**Submission to:  
IEEE P802.11  
Wireless LANS**

Title: **Proposed Modifications to M-ary Bi-Orthogonal Waveform Presented in  
doc:IEEE P802.11-97/144**

Date: January 1998

Figure 1 (A) Proposed Transmitter for "full-data-rate"

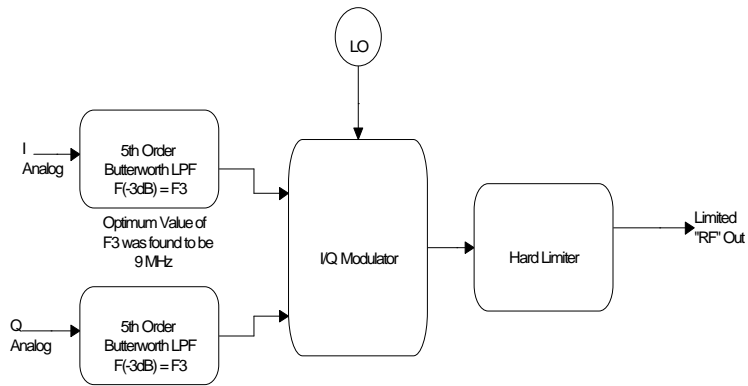
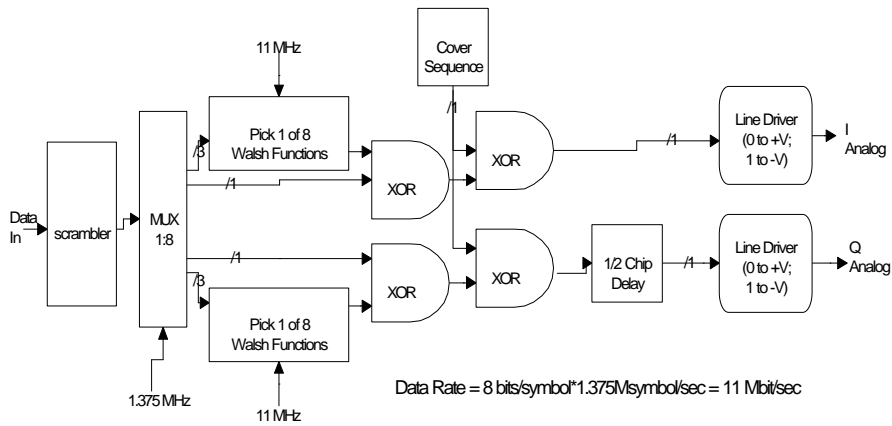
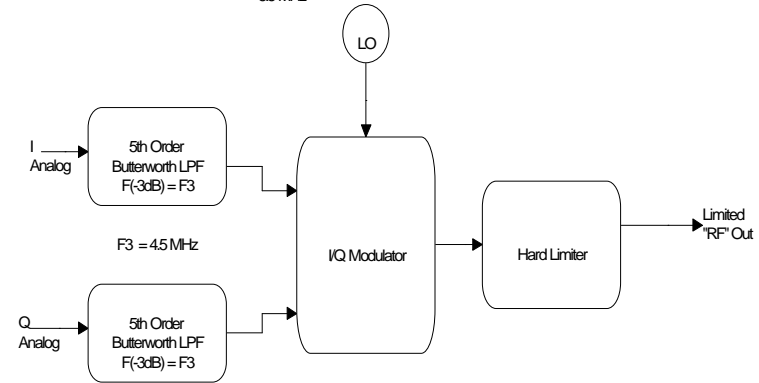
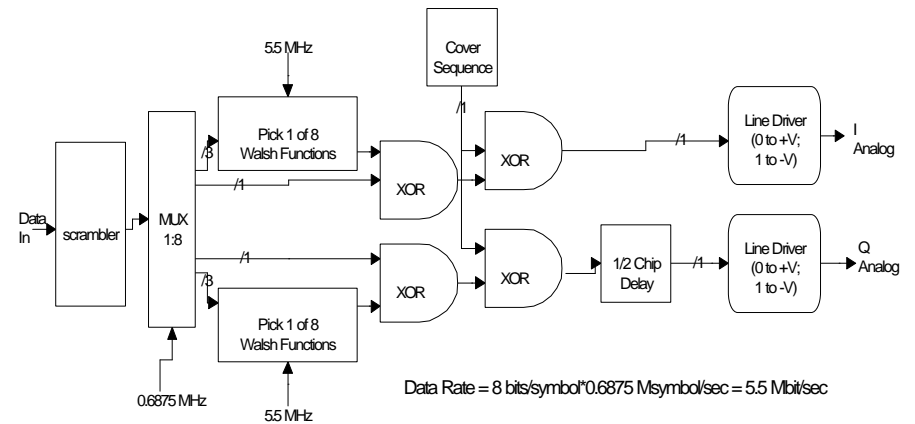
It is well known [2] that Offset Quadrature Phase Shift Keying exhibits less spectral growth through a saturated power amplifier than Quadrature Phase Shift Keying. This principle can be applied to the proposed waveform by delaying the Q channel  $\frac{1}{2}$  a chip period more than the I channel. This is shown in Figure 1A. (Compare this with page 15 of [1].) Since the waveform proposed in [1] already requires the receiver process the signal coherently, it can distinguish the I from the Q channel, and re-align them.

This is one reason to also use offset quadrature modulation for the half-data-rate case. The transmitter implementation is shown in figure 1B. (Compare this with page 17 of [1].) Another reason is to reduce the occupied bandwidth, even with a linear power amplifier, to allow for more channels. In a three-dimensional office environment, modeling cells as cubes, there are often up to six other networks which can interfere with the network being used. (The power level for interference is lower than the power level for reliable reception.) For this reason, at least seven different frequency channels are desired. With 11 MHz chipping, only 3 or 4 channels are achieved. By halving the chipping rate and data rate, the spectrum of Figure 3 is halved. The bandwidth between -20 dBc points is then 11 MHz. (This is approximately one-fifth the bandwidth of the binary approach.) We achieve 7 distinct channels, with a saturated power amplifier.

Figure 2 Effect of LPF -3dB BW (F3) on -20 dBc to -20 dBc BW of Hardlimiter Output; Fchip = 11 MHz;

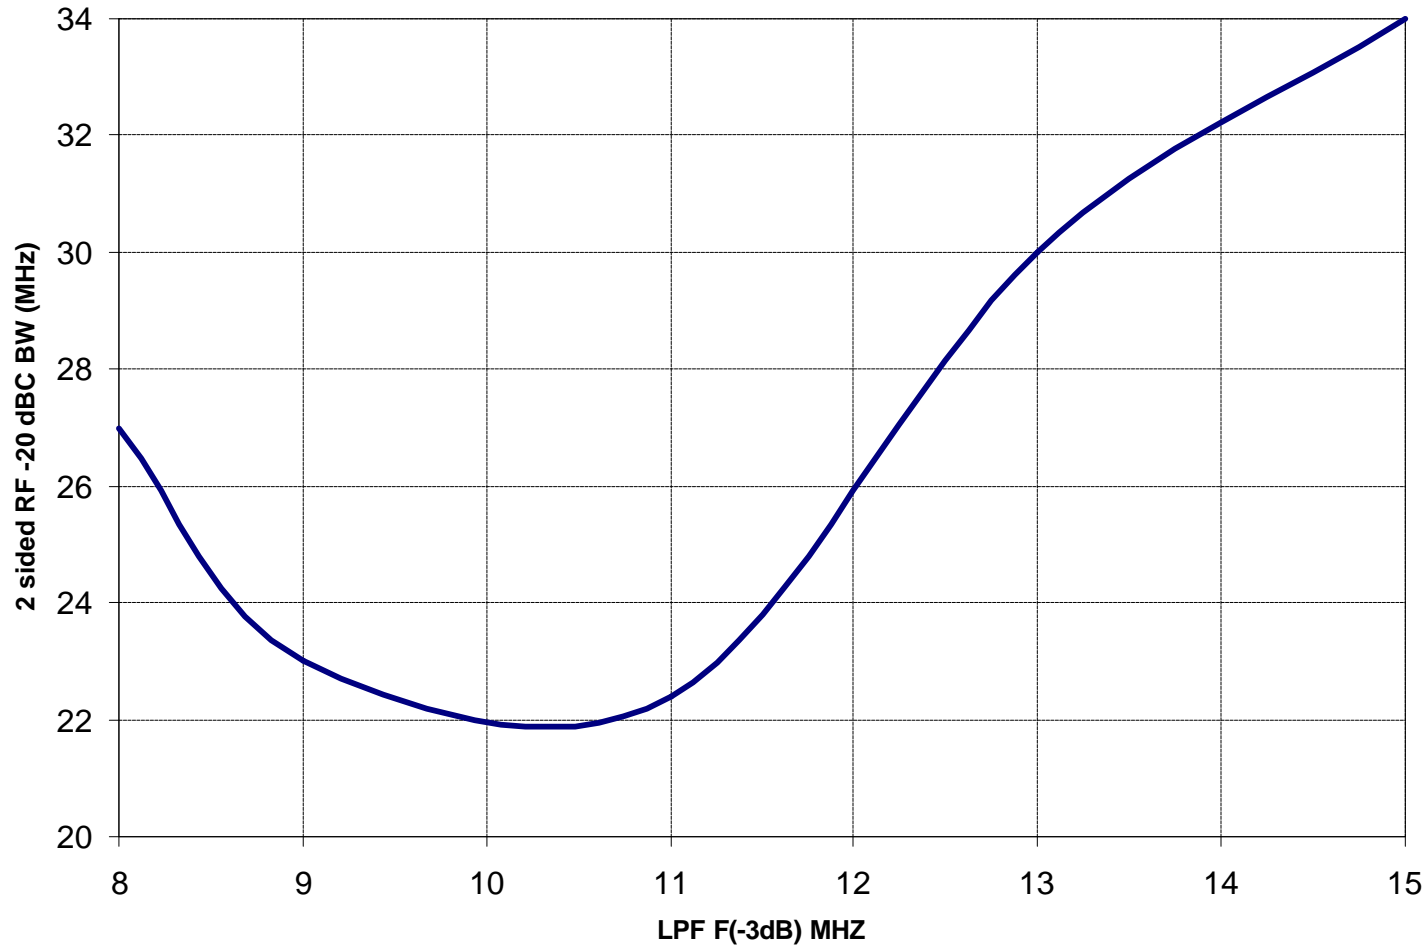
We ran a simulation to determine the performance of the transmitter proposed in Figure 1A. Both the I and Q baseband "rails" were filtered by a 5<sup>th</sup> order Butterworth Low Pass Filter of -3dB bandwidth F3. We determined the spectrum on the hard limiter output from the FFT of the RF waveform with random data applied to the modulator. Figure 2 shows how the bandwidth between the two points 20 dB below the peak of the signal varied as F3 was changed. We selected F3 = 9 MHz. (A bandwidth slightly less than "optimum" was selected to simulate implementation tolerances.) The spectrum that a spectrum analyzer would give in "peak hold" mode was estimated from the simulation output spectrum. This is shown in Figure 3. From this, it is obvious that 3 or 4 channels would fit into the 83 MHz band, even though this is the output of a hard limiter. This spectrum does not meet the present IEEE802.11 spectral mask requirements for the 1 and 2 Mb/s Direct Sequence waveforms. However, there is no reason a new mask could not be used for the new waveform, as long as FCC requirements are met.

**Figure 4 Spectrum of Hardlimiter Output.** I and Q Aligned in time; F(chip) = 11 MHz (full-data-rate as proposed in reference [1])

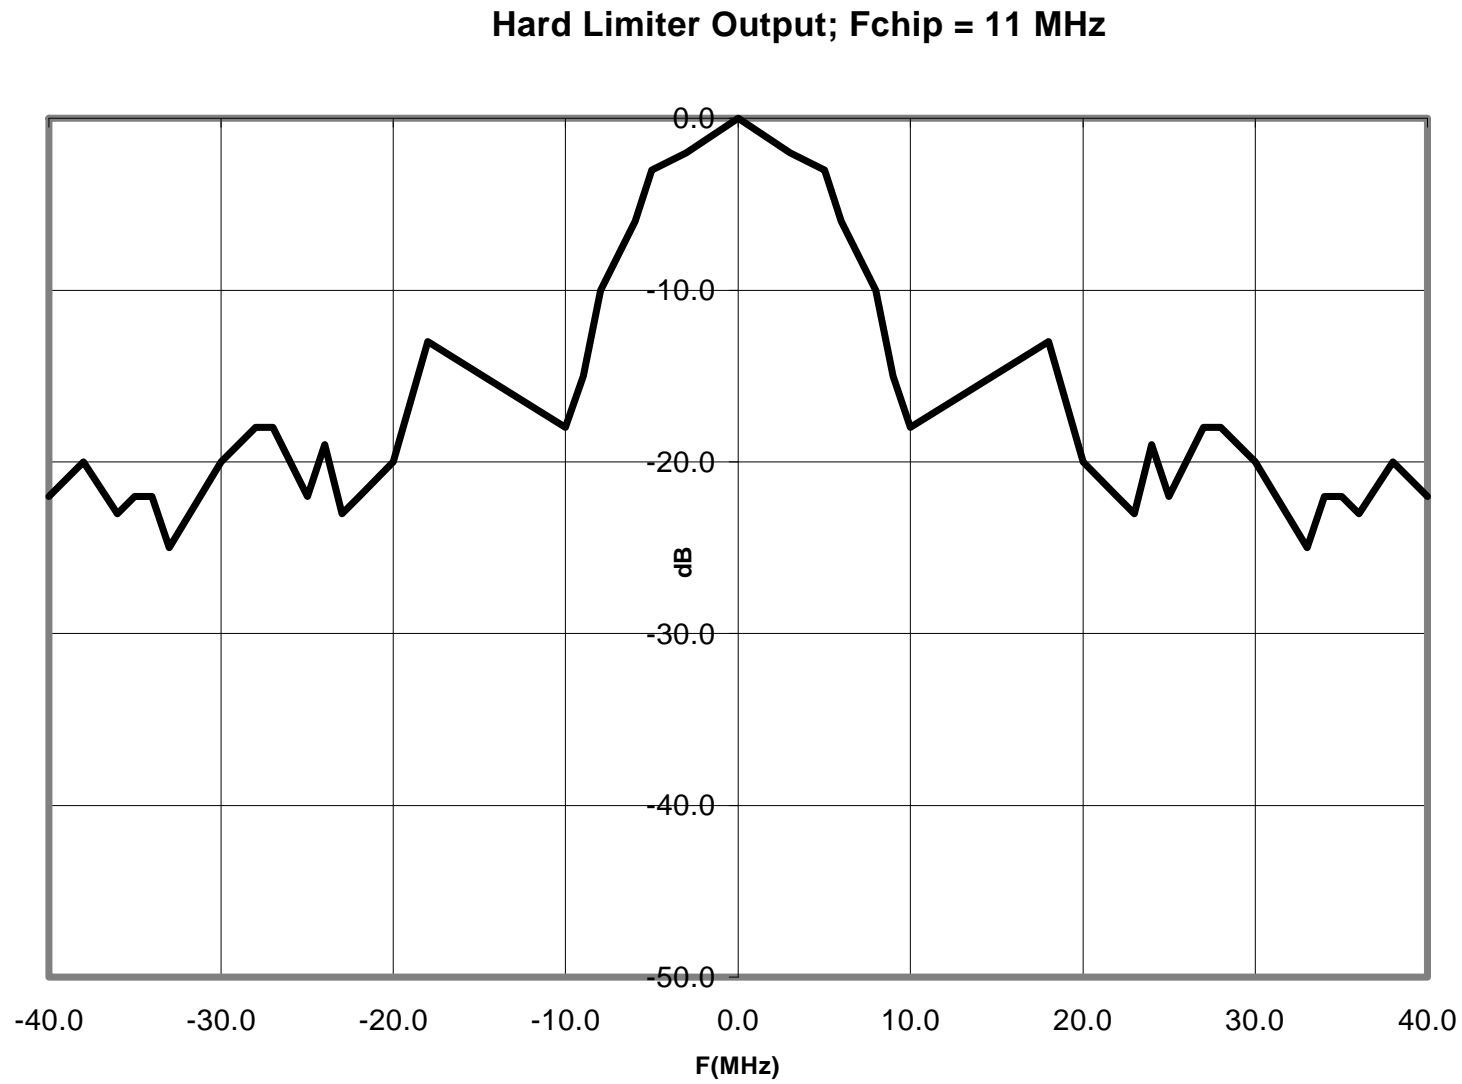
For the sake of comparison, the case of I and Q aligned in time was simulated. The same procedure to find the best bandwidth for the single I-channel 5<sup>th</sup> order Butterworth LPF was repeated. The best bandwidth was 5.5 MHz. Figure 4 shows the resulting spectrum, again at the hard limiter output. The bandwidth between the -20 dBc points is 60 MHz. Only one channel would fit in the allocated band.

Figure 5 Spectrum of Hardlimiter Output. I Channel Only used; F(chip) = 5.5 MHz (half-data rate as proposed in reference [1])

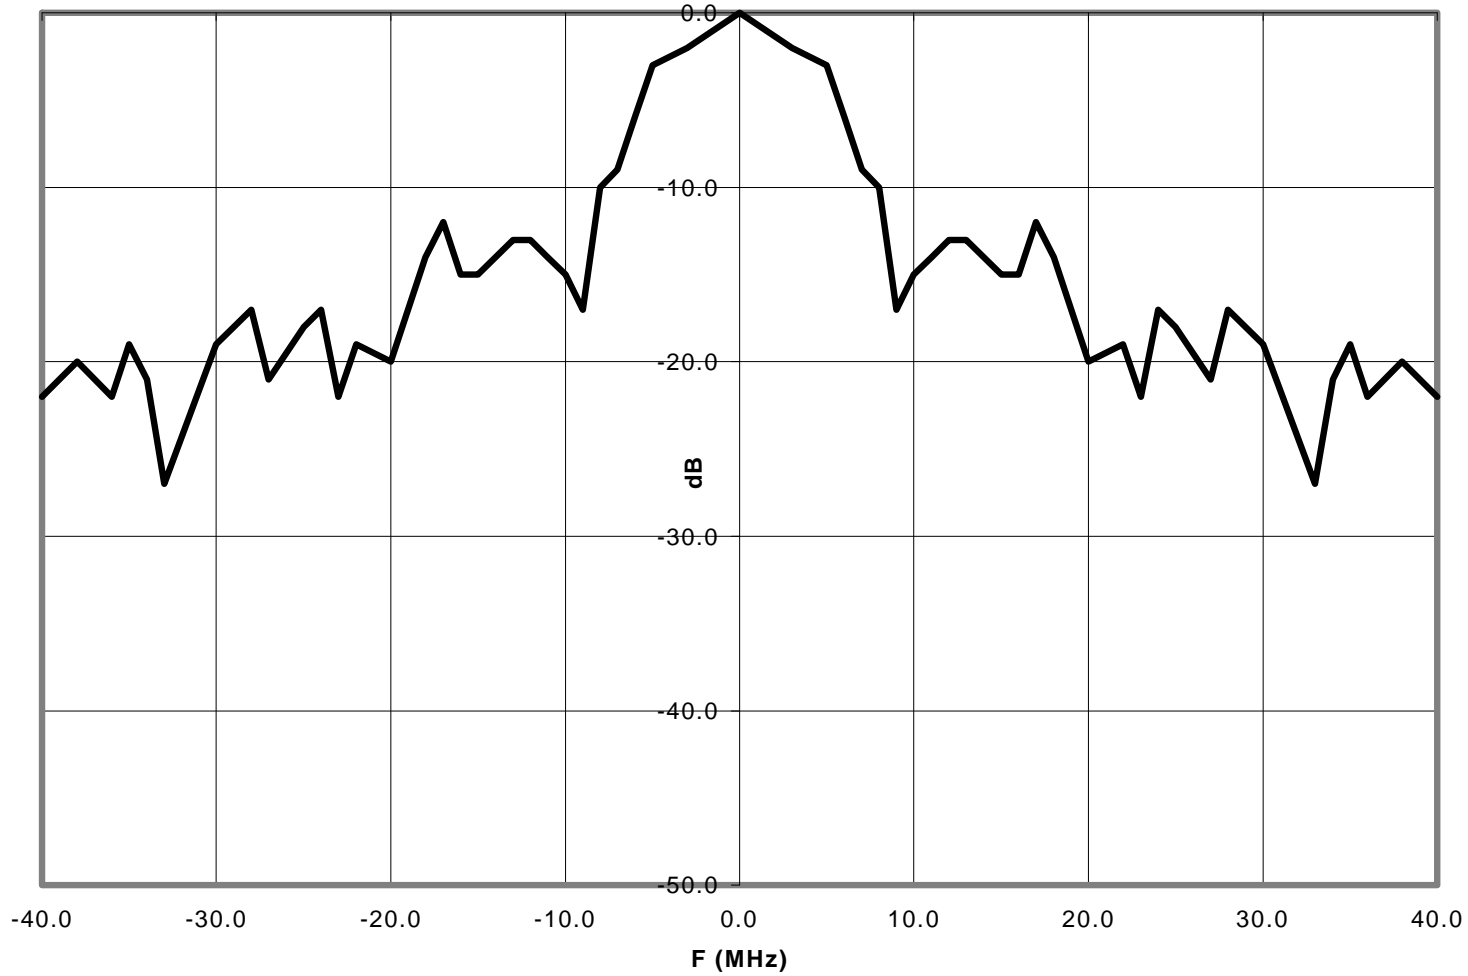
In [1] binary, rather than quadrature, modulation was proposed for the half-data-rate case. Binary modulation exhibits more spectral growth through a saturated power amplifier than does offset quadrature modulation. This is because it goes through the origin of the I/Q plane, so has a high amplitude variation. We simulated this modulation. The same procedure to find the best bandwidth for the single I-channel 5<sup>th</sup> order Butterworth LPF was repeated. The best bandwidth was 5.5 MHz. Figure 5 shows the resulting spectrum, at the hard limiter output. The bandwidth between the two -20 dBc points is approximately 60 MHz. (Even though the data rate was halved, this method still uses a chipping rate of 11 MHz.) Only one channel would fit in the allocated band.

Figure 6 (A) Transmitter with Appended Walsh for full-data-rate. (B) Transmitter with Appended Walsh for half data rate.

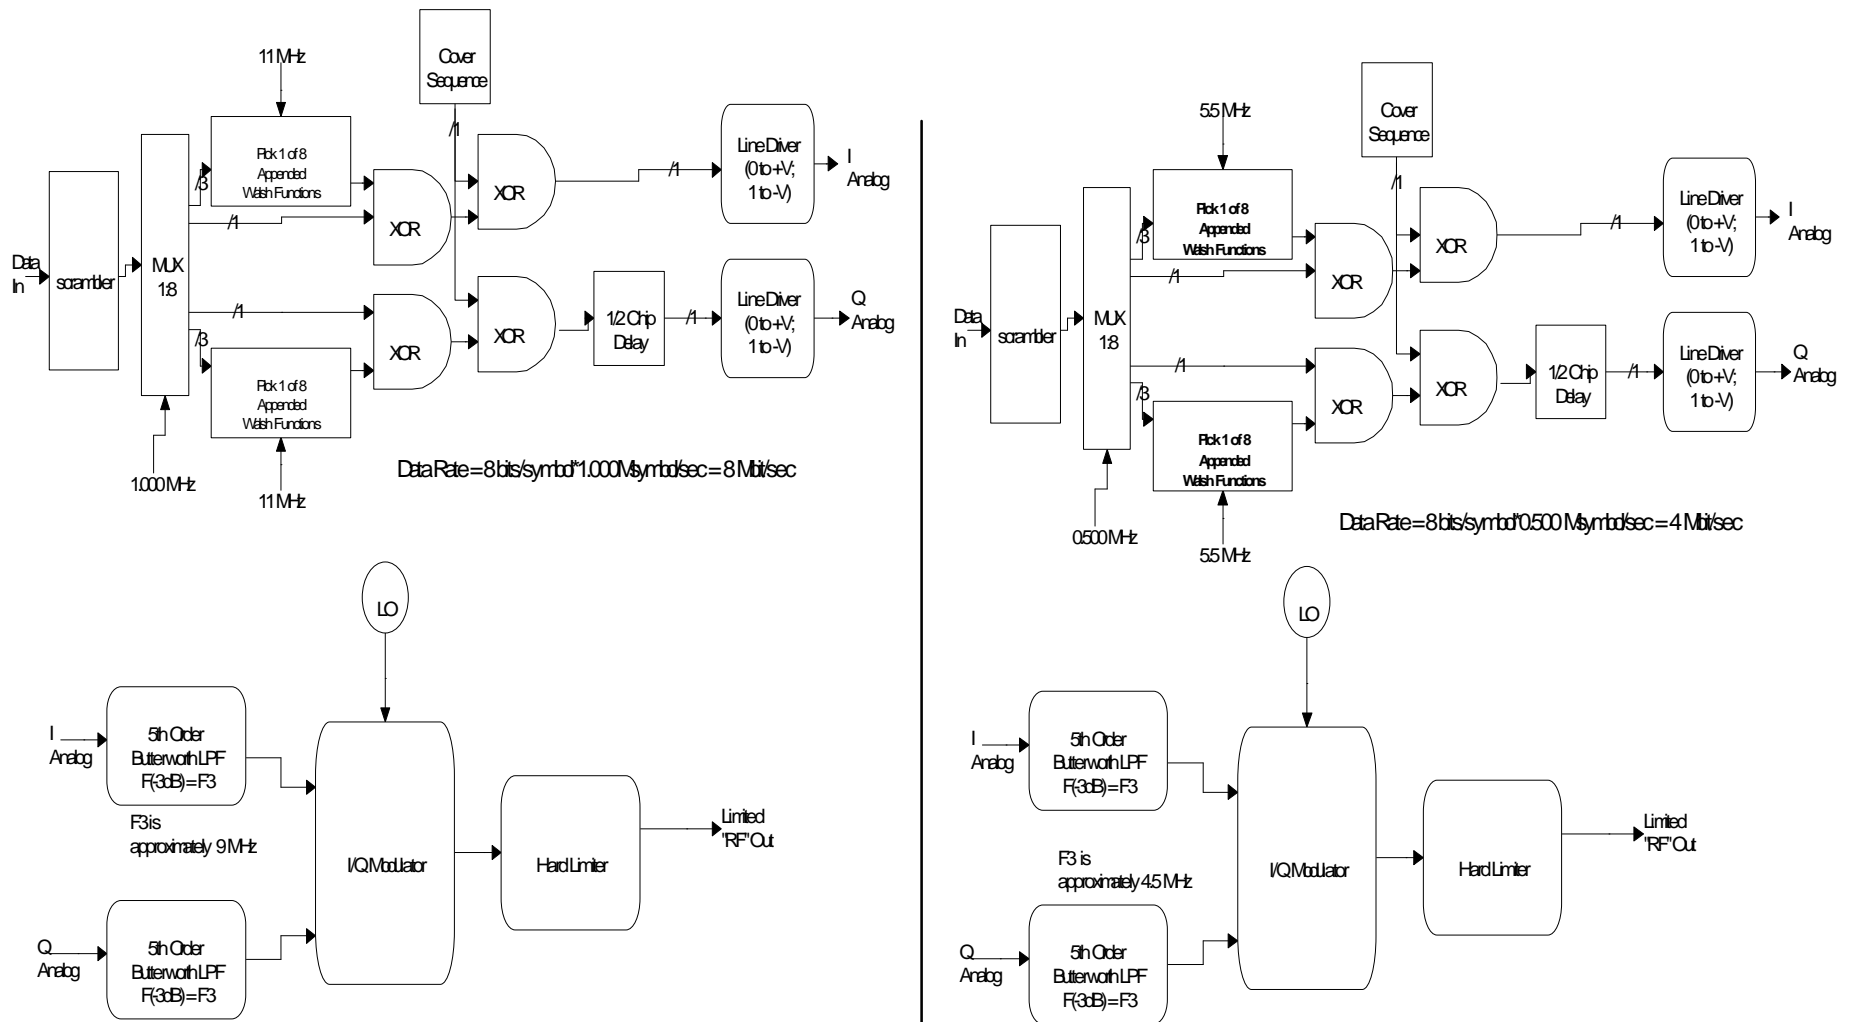
There has been some question if the waveform proposed in [1] will meet FCC requirements with only 8 chips in each symbol. To eliminate this question, we propose adding 3 chips to each Walsh function. This is shown in Figures 6 (A) and 6 (B). One of eight possible symbols is still transmitted. Each symbol now has eleven, rather than eight, chips. In order to keep enough frequency channels in the allocated band, we propose keeping the 11 Mb/s chipping rate, and decreasing the data rates to 8 Mb/s (full rate) and 4 Mb/s (half rate).
